May 6, 2016
RC-16-0077

Subject: VIRGIL C. SUMMER NUCLEAR STATION (VCSNS) UNIT 1
DOCKET NO. 50-395
OPERATING LICENSE NO. NPF-12
RELIEF REQUEST RR-III-12 PROPOSED ALTERNATIVE INSPECTION
REQUIREMENTS FOR PIPING WELDS – RESPONSE TO REQUEST FOR
ADDITIONAL INFORMATION

VCSNS Response to Request for Additional Information

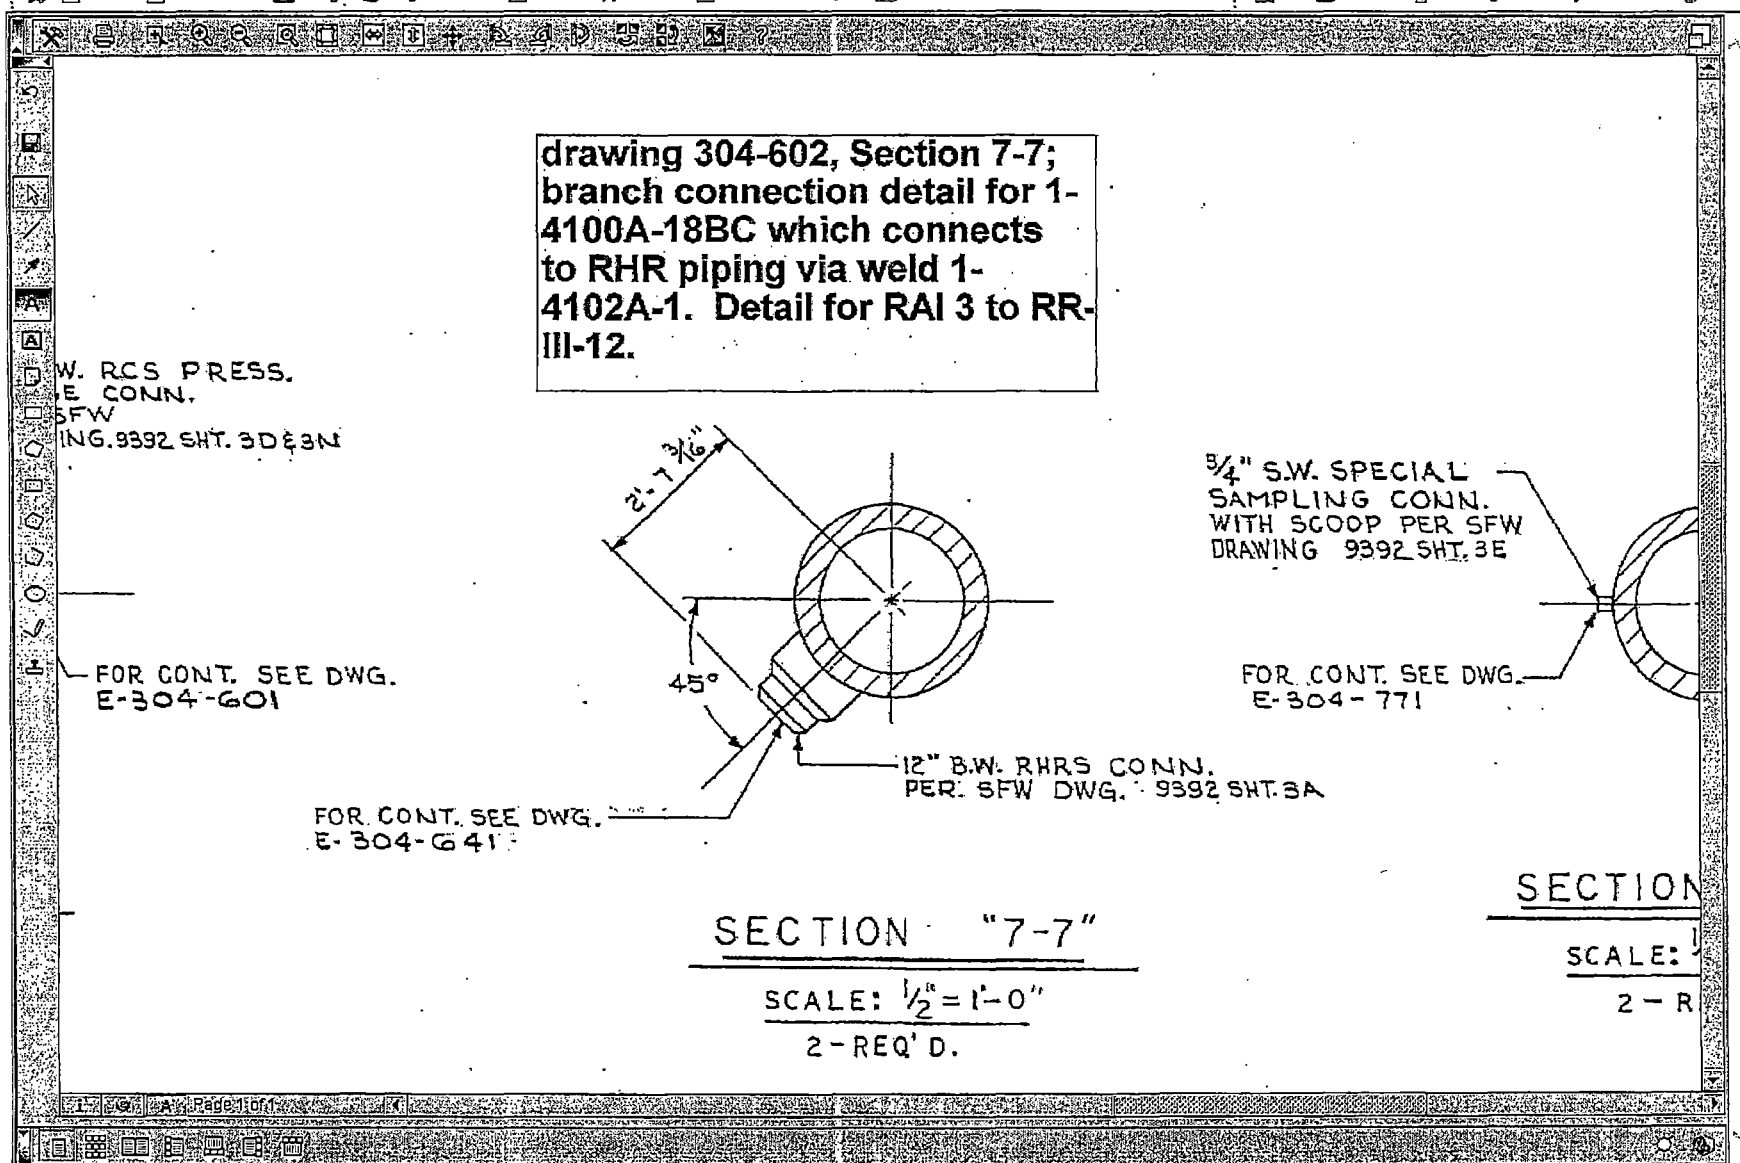
1-4102A-1: 12 in. diameter, 1.125 in. thick SS Pipe - SS Weld - SS Branch Connection to SS A HL

- The full single sided exam performed on this weld means that only 50% of the full bi-directional weld was able to be performed. The ability to examine the exam volume fully in one direction only intended that the calculation was not necessary as this is 50% of the full bi-directional exam. Weld details and examination data sheets are provided in Attachment III.

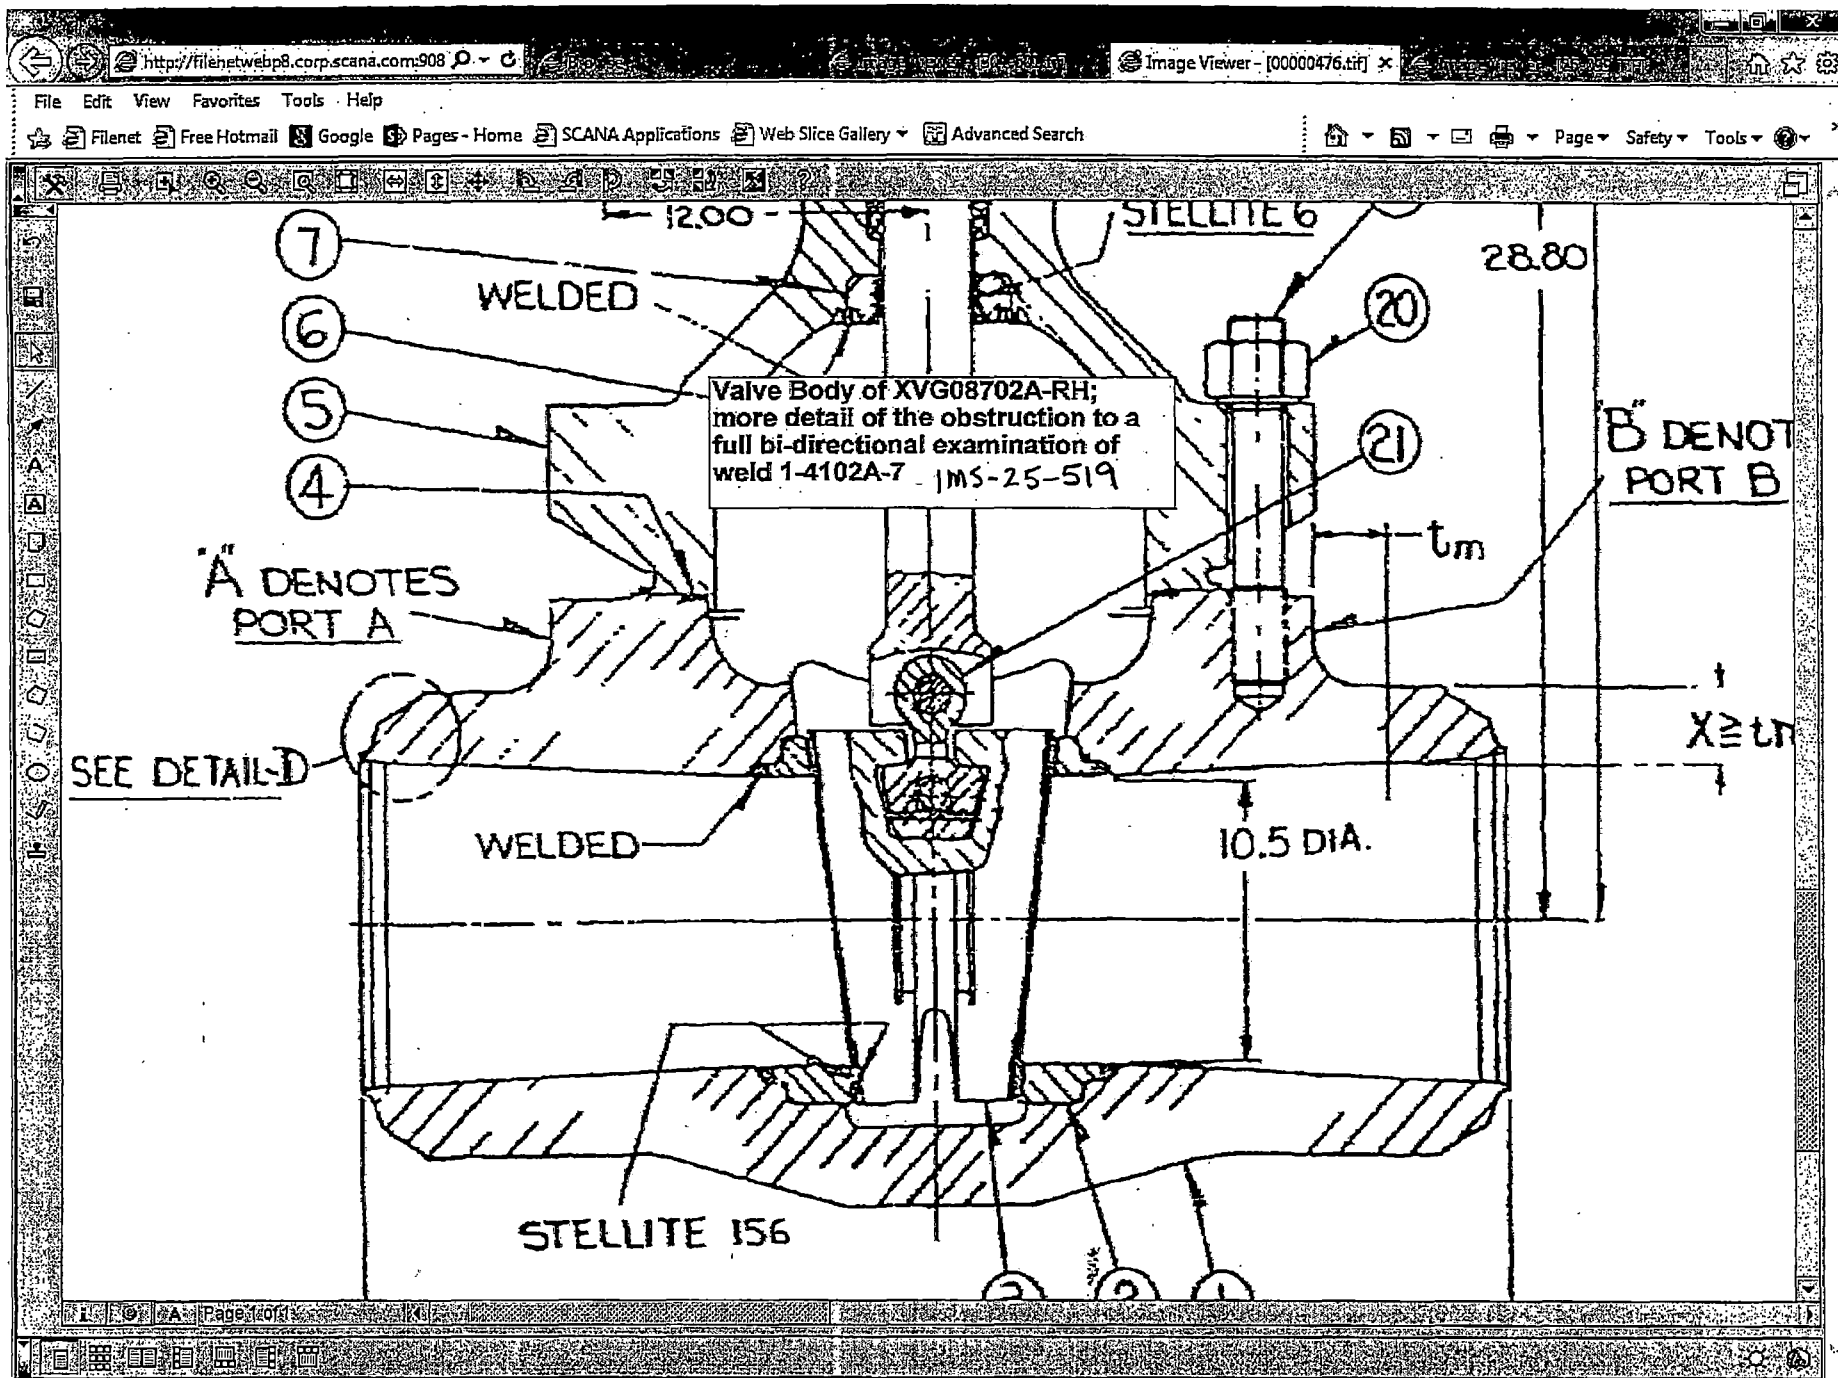
1-4102A-7: 12 in. diameter, 1.125 in. thick SS Pipe - SS Weld - SS Valve Body of XVG08702A-RH

- The full single sided exam performed on this weld means that only 50% of the full bi-directional weld was able to be performed. The ability to examine the exam volume fully in one direction only intended that the calculation was not necessary as this is 50% of the full bi-directional exam. Weld details and examination data sheets are provided in Attachment IV.

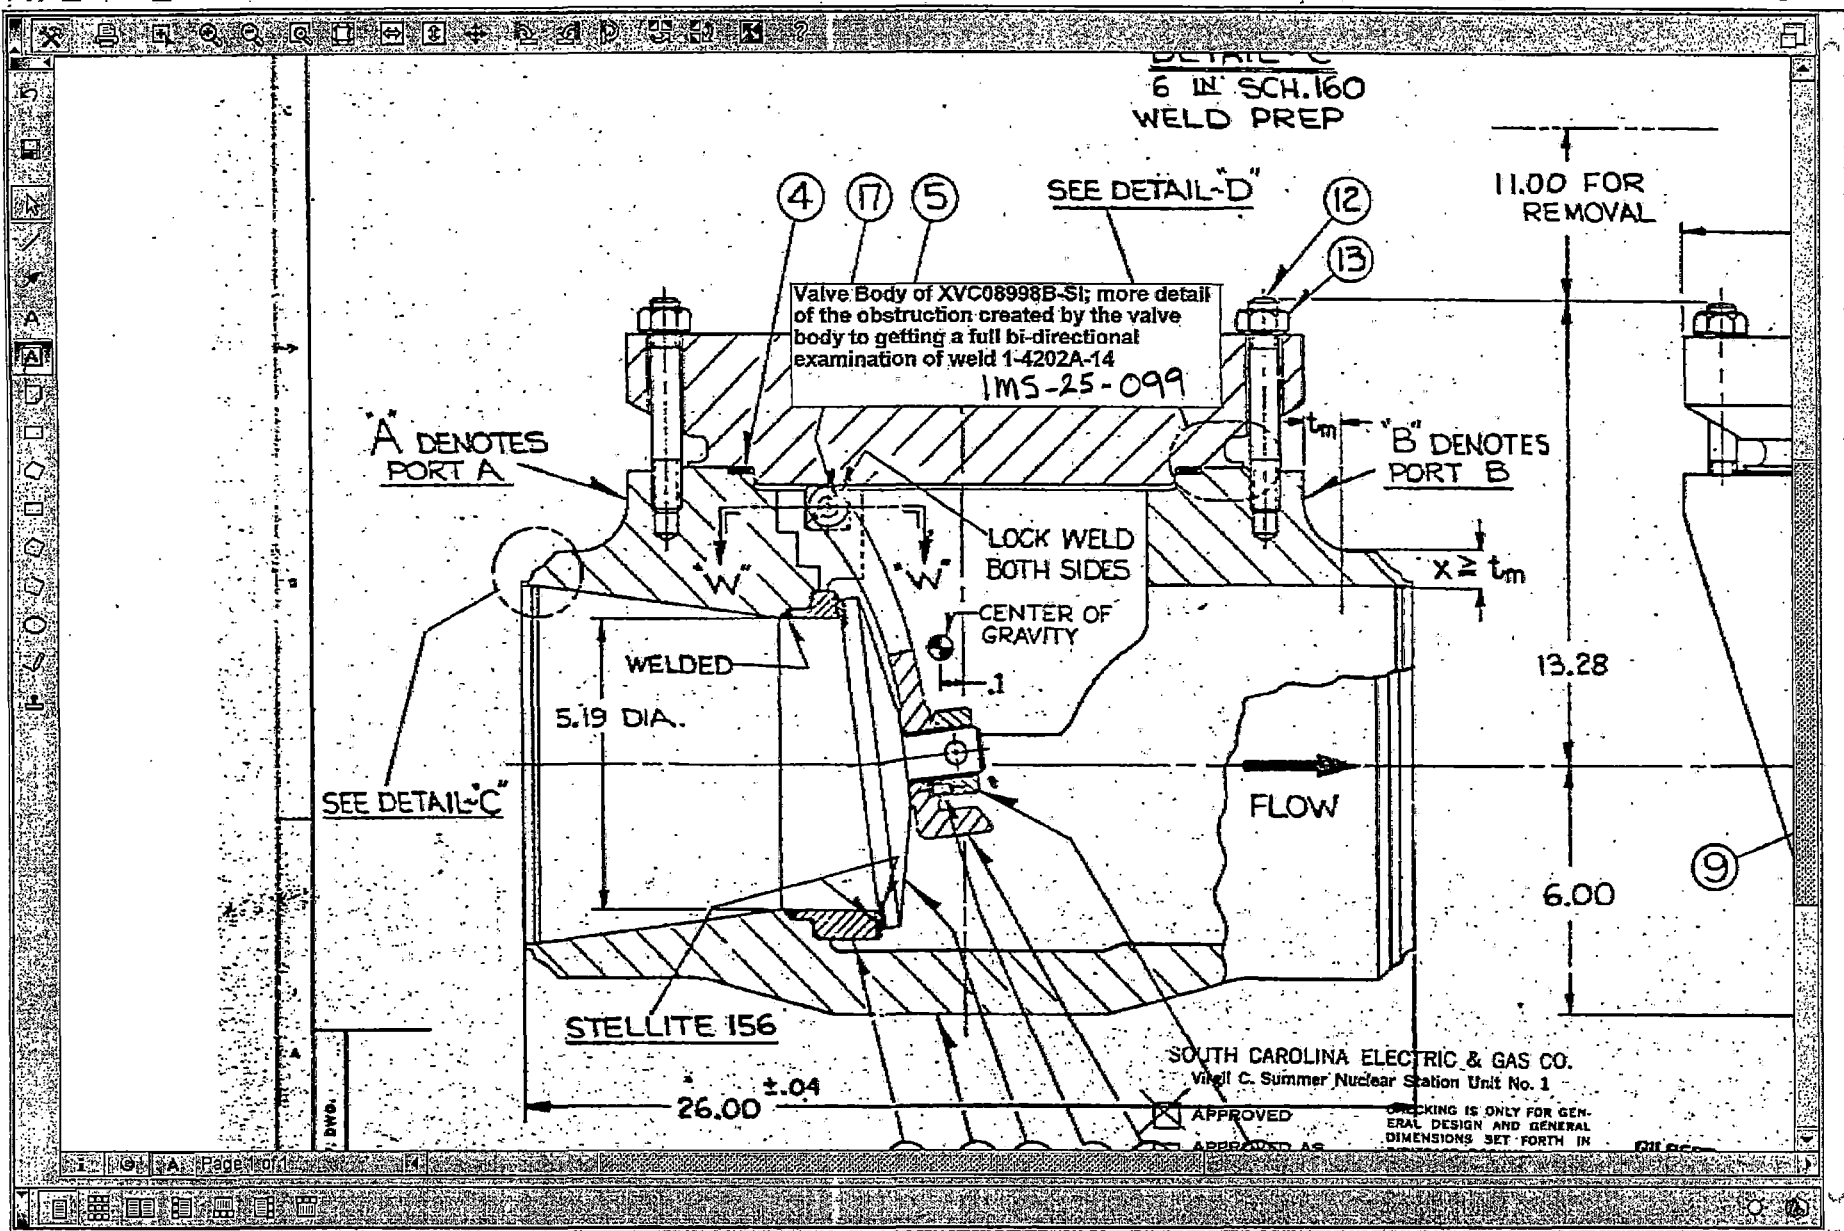
1-4202A-14: 6 in. diameter, 0.719 in. thick SS Pipe - SS Weld - SS Valve Body of XVC08998B-SI

- The full single sided exam for this weld is partially obstructed by a branch connection on the pipe, 1-4202A-24BC, thus not allowing the full 50% coverage for the single sided exam. Weld details, coverage calculations and examination data sheets are provided in Attachment V.

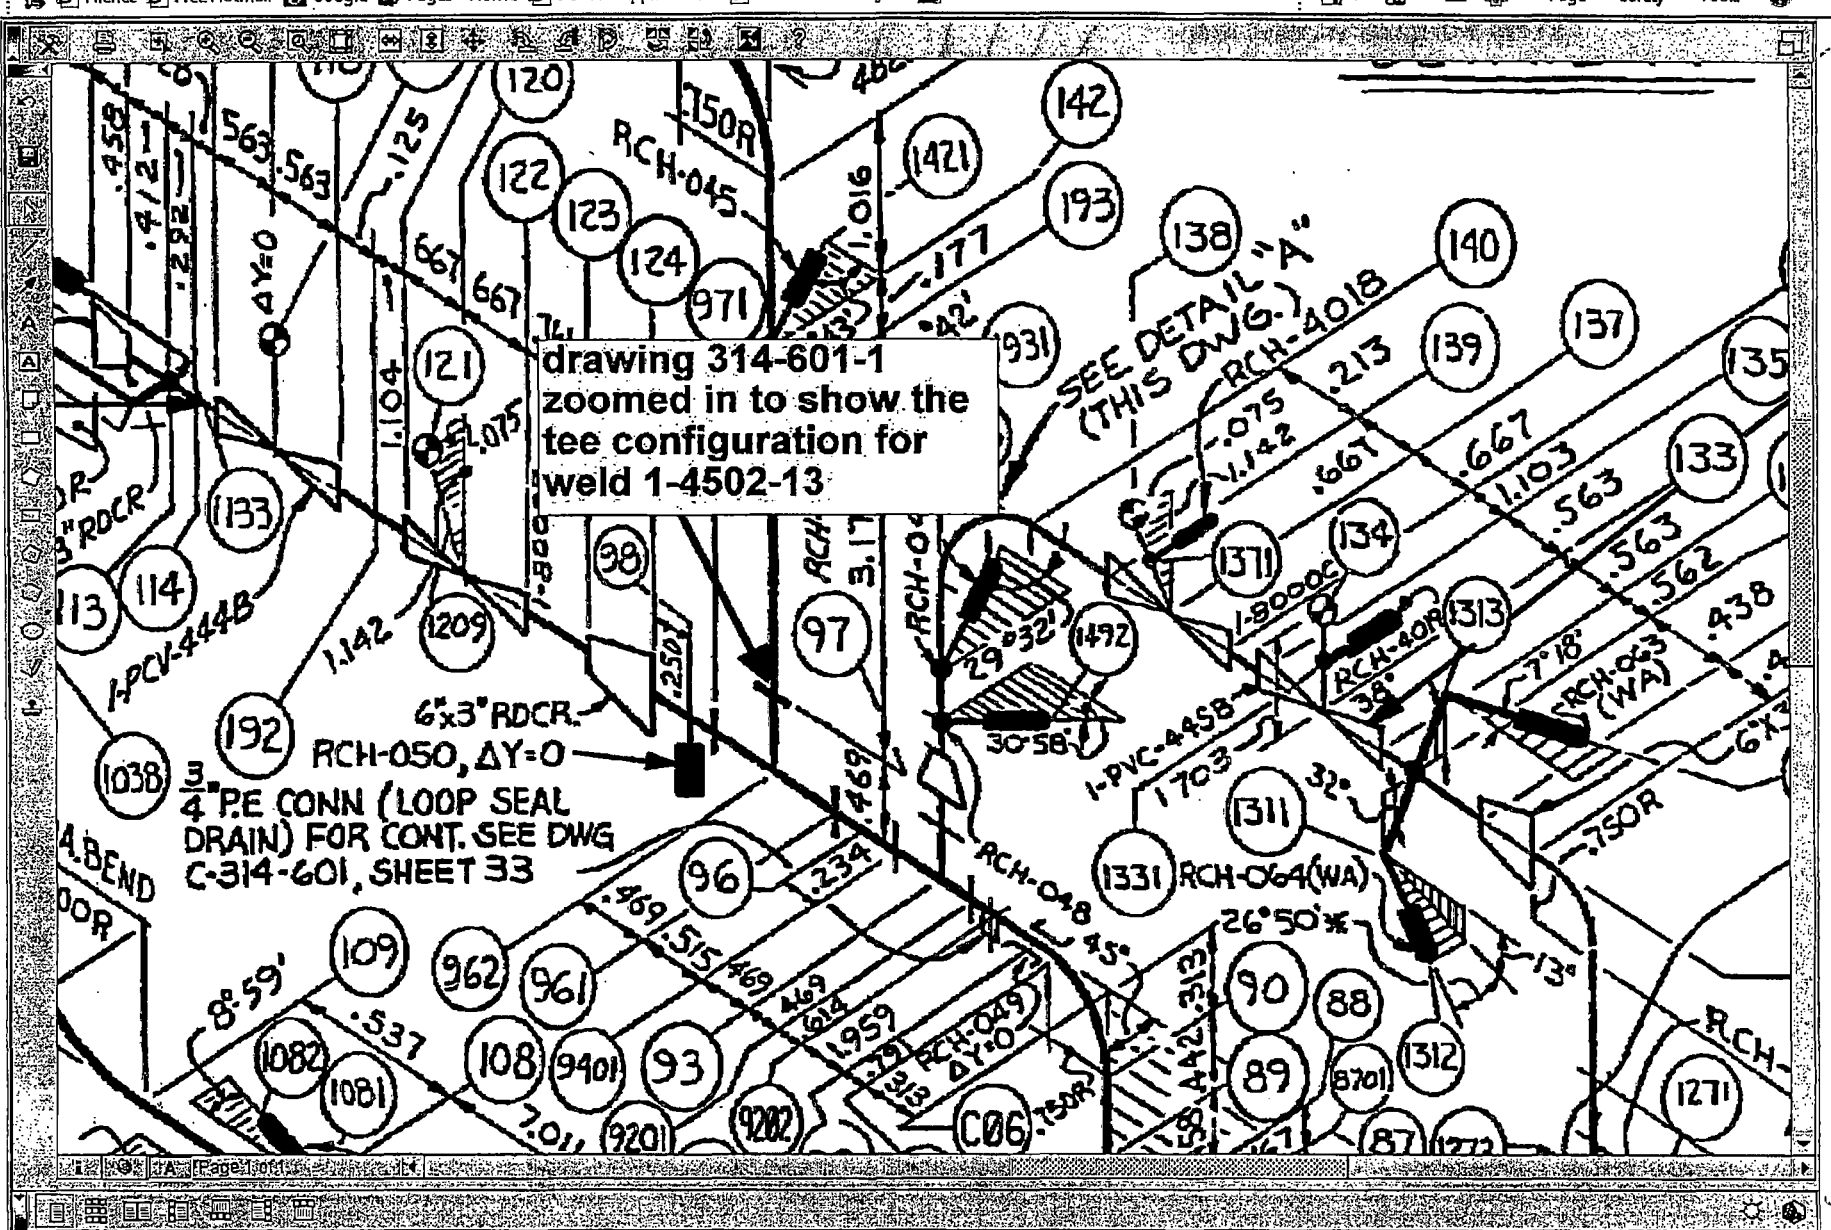
1-4502-13; 6 in. diameter, 0.719 in. thick SS Pipe - SS Weld - SS Pipe Tee

- The full single sided exam performed on this weld means that only 50% of the full bi-directional weld was able to be performed. The ability to examine the exam volume fully in one direction only meant that the calculation was not necessary as this is 50% of the full bi-directional exam. Weld details and examination data sheets are provided in Attachment VI.
